City of Corpus Christi

Planning Commission

Wednesday, March 3, 2021

**TECHNICAL REVIEW PLAT REQUIREMENTS
REGULAR PLANNING COMMISSION MEETING
March 3, 2021**

DATE PLOTTED: 12/15/20
FILE: PLAT-SH2
JOB NO.: 19004
SCALE: 1' = 50'
PLOT SCALE: SAME
SHEET 3 OF 3

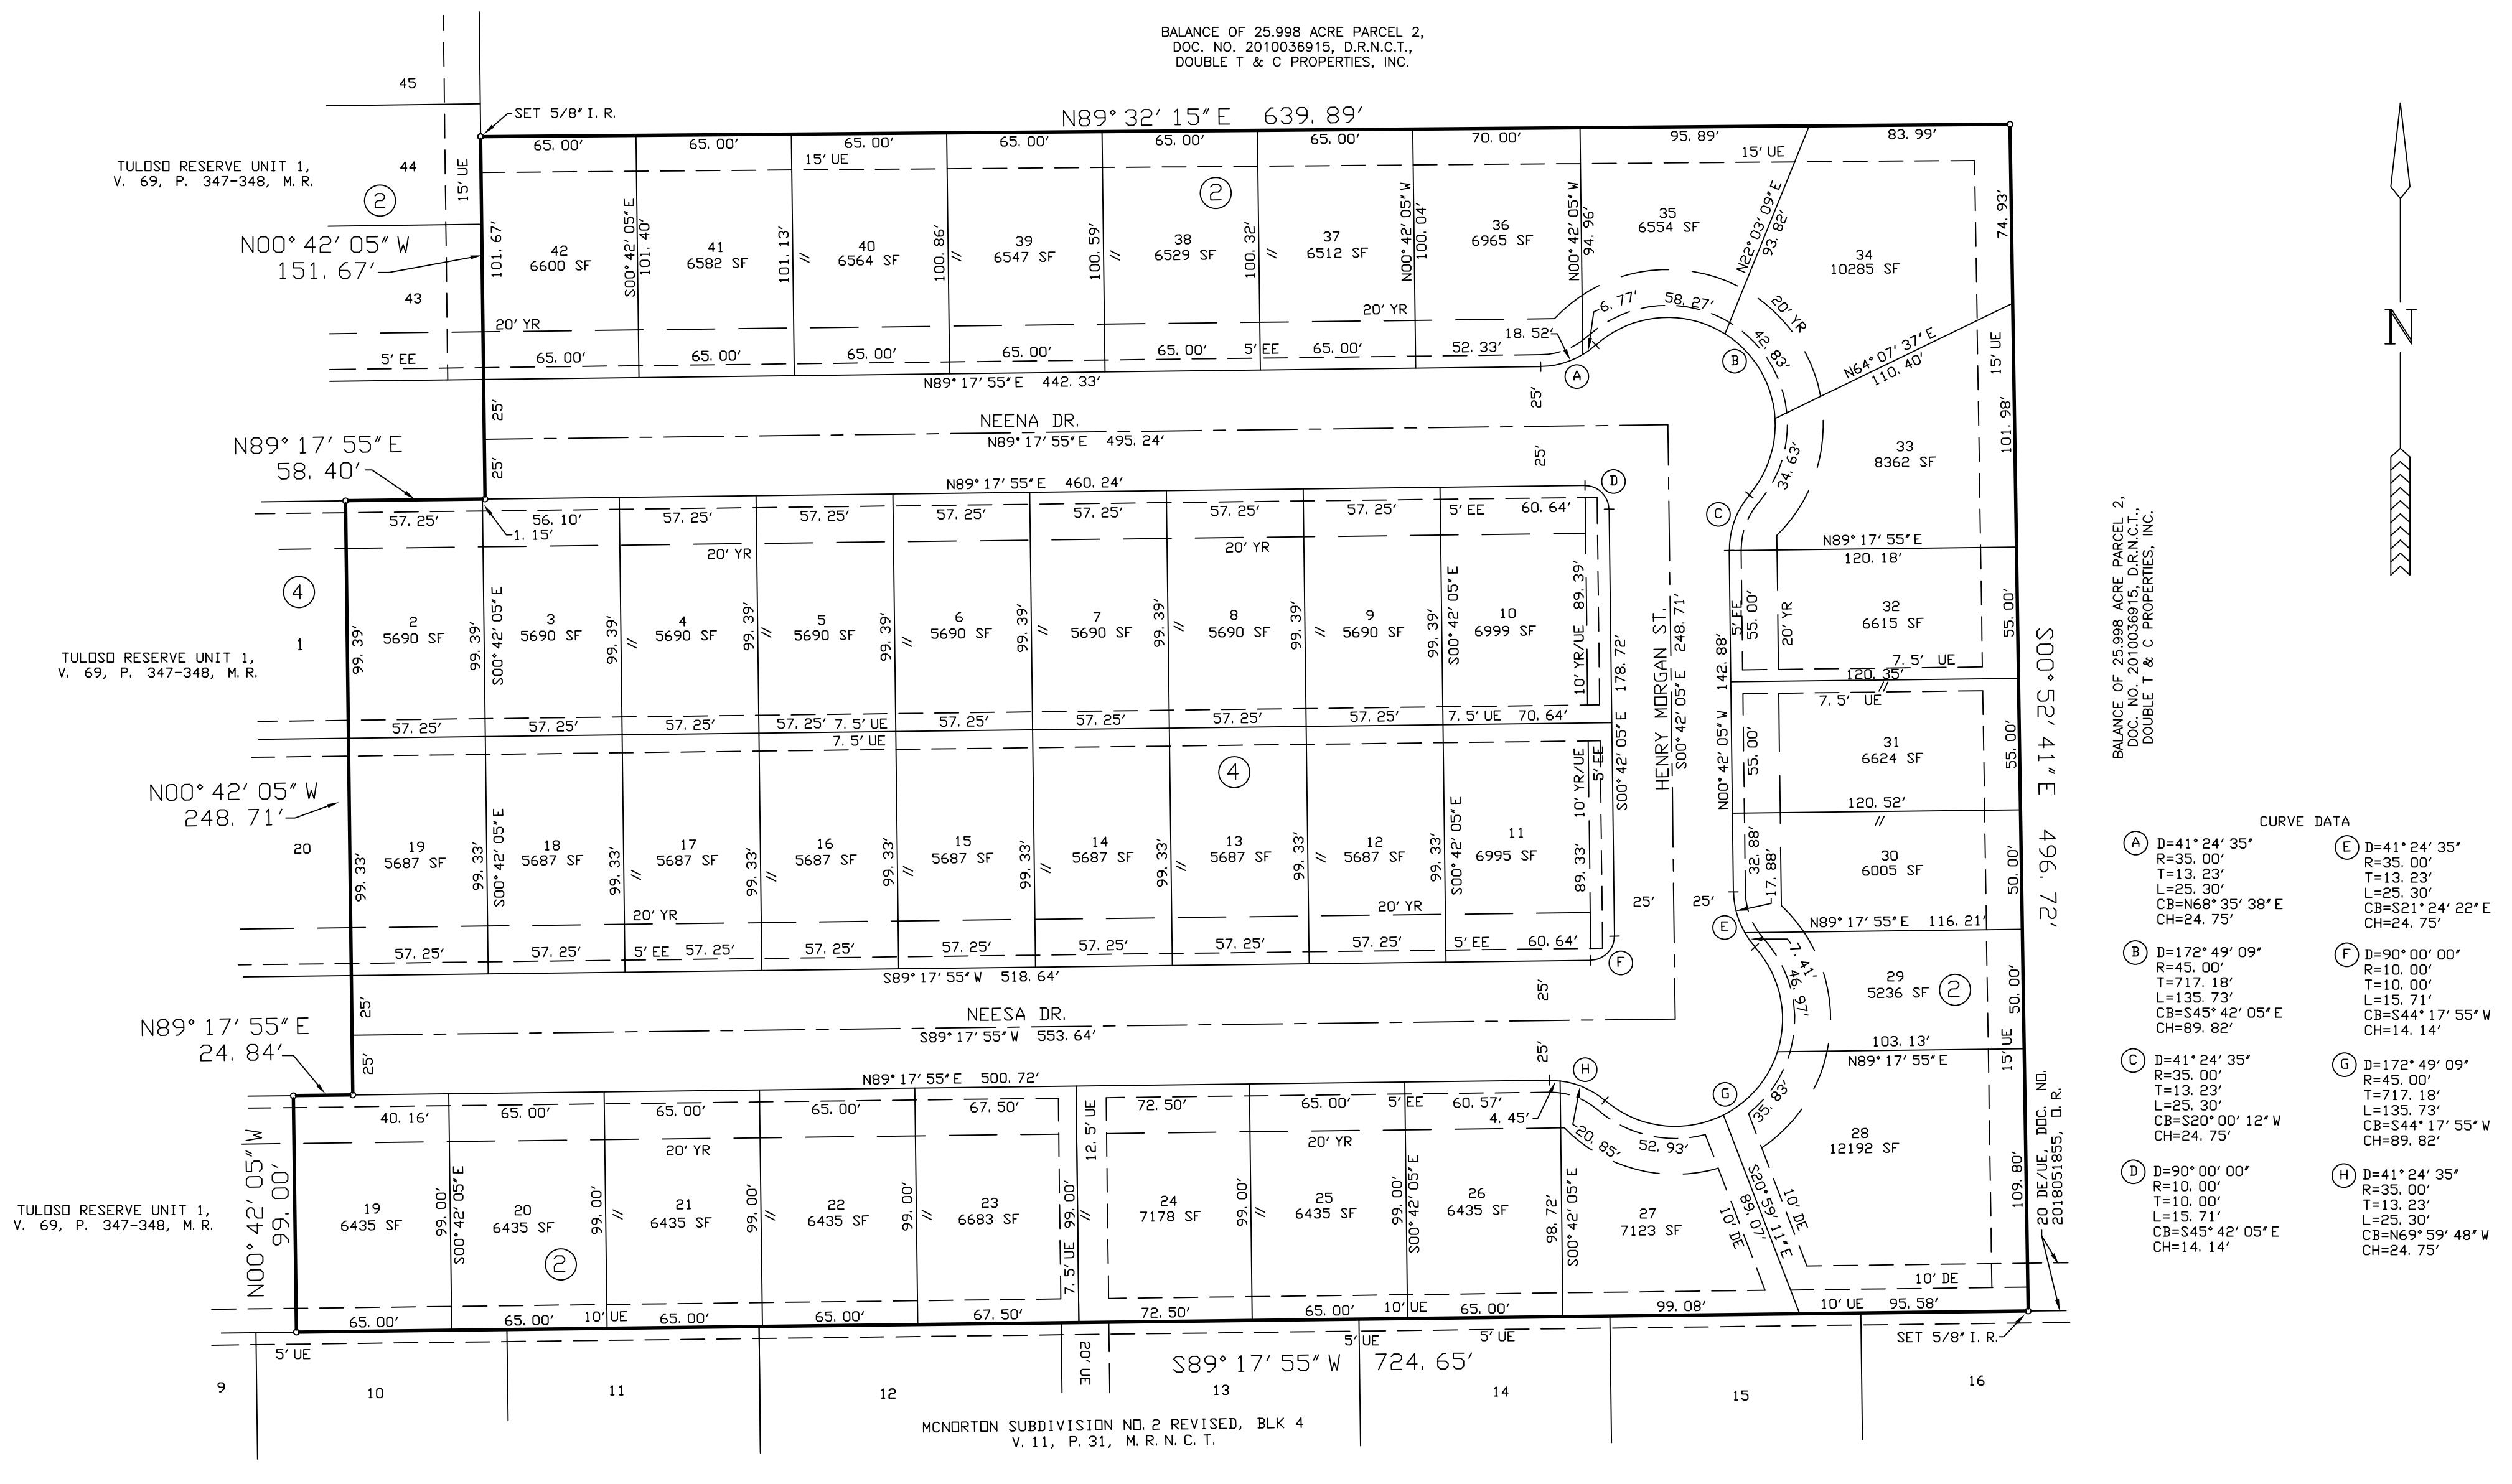
GIS						
No.	Sheet	Comment	Applicant Response	Staff Resolution	Applicant Response	Staff Resolution
1	Plat	The plat closes within acceptable engineering standards.	OK	Resolved		
2	Plat	Update document number for northeast adjacent lot (#2010036915)	DONE	Resolved		
3	Plat	Update street names on utility plan.	DONE	Resolved

DEVELOPMENT SERVICES ENGINEERING						
No.	Sheet	Comment	Applicant Response	Staff Resolution	Applicant Response	Staff Resolution
1		Public Improvements Plans are required prior to plat recordation; submit a pdf copy of proposed public improvements along with a title sheet to PublicImprovements@cctexas.com for review and approval; this item is required prior to Final Plat Recordation. UDC 8.1.3.A	OK	Will be addressed Prior to Plat Recordation.		
2	Plat	Add the following note "all driveways shall conform to access management standards outlined in Article 7 of the UDC".	DONE	Addressed		
3	SWQMP	Add the following note to the plat "All street SIGNS (including STOP signs) and markings must be furnished and installed by the Developer".	DONE (PLAT)	Addressed		
4	Utility Plan	Add the following note to the plat "The FF elevation for each lot must be 18 inch higher than the highest CL elevation fronting the lot.".	DONE (PLAT)	Addressed

5		Add the following note to the plat "All lots driveways must be located on the shorter length of the lot.".	DONE	Addressed		
6	Plat	Submit the offsite UE's for processing and recordation to ContractsAndAgreements@cctexas.com.	OK	Will be addressed Prior to Plat Recordation.		
7		Add the following note "Street lights location map will be provided with each Final Plat.".	Will be provided in construction plans.	Will be addressed Prior to Plat Recordation.		
8		Please confirm that the storm basin is not "Inner harbor Basin".	It is Oso Creek Basin.	Addressed

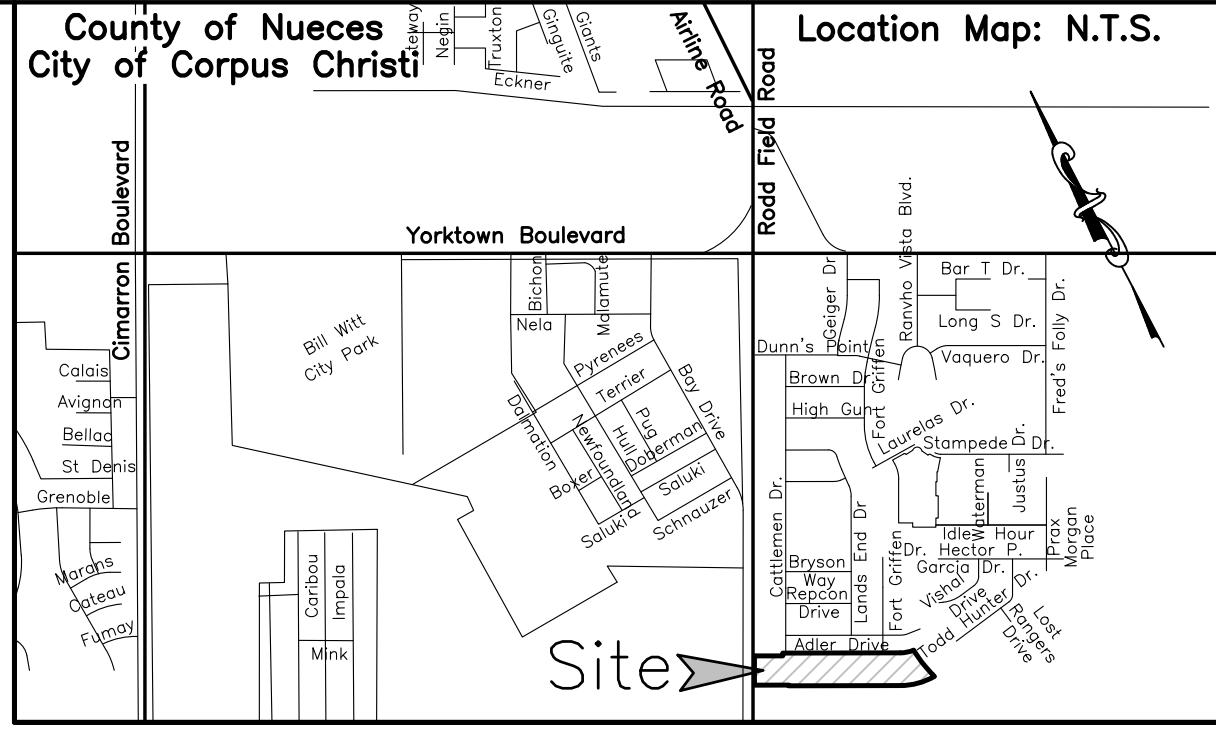
GIS						
No.	Sheet	Comment	Applicant Response	Staff Resolution	Applicant Response	Staff Resolution
1	Plat	The plat closes within acceptable engineering standards.	Understood			
2	Plat	Pls adjust platted area on location map.	Correction has been made	Resolved.

No.	Sheet	Comment	Applicant Response	Staff Resolution	Applicant Response	Staff Resolution
1	Plat	On the Planning Commission certificate block revise the Secretary name to read: "Al Raymond III, AIA"	Correction has been made	Addressed		
2	Plat	The legal description for Block 35, Lots 3-14, is incorrect. Correct and revise.	Correction has been made	Addressed		
3	Plat	Identify the dashline on Block 38, between Lots 2 & 3	Label has been added	Addressed		
4	Plat	Along the south end property line of Block 38, Lot 7, show and label the continuing of the 5'U.E by separate instrument.	Easement has been extended	Addressed		
5	Plat	Identify the dashlines along the east end of Block 35, Lot 24 and Block 39, Lot 23.	Labels have been added	Addressed		
6	Plat	Prior to recordation show and label the recording information Block 35, Lots 3-14	Recording information has been added	Addressed

1	Plat	Provide 5" U.E. south side of Lot 7, Block 38	Offsite easement has been extended			
---	------	---	------------------------------------	--	--	--
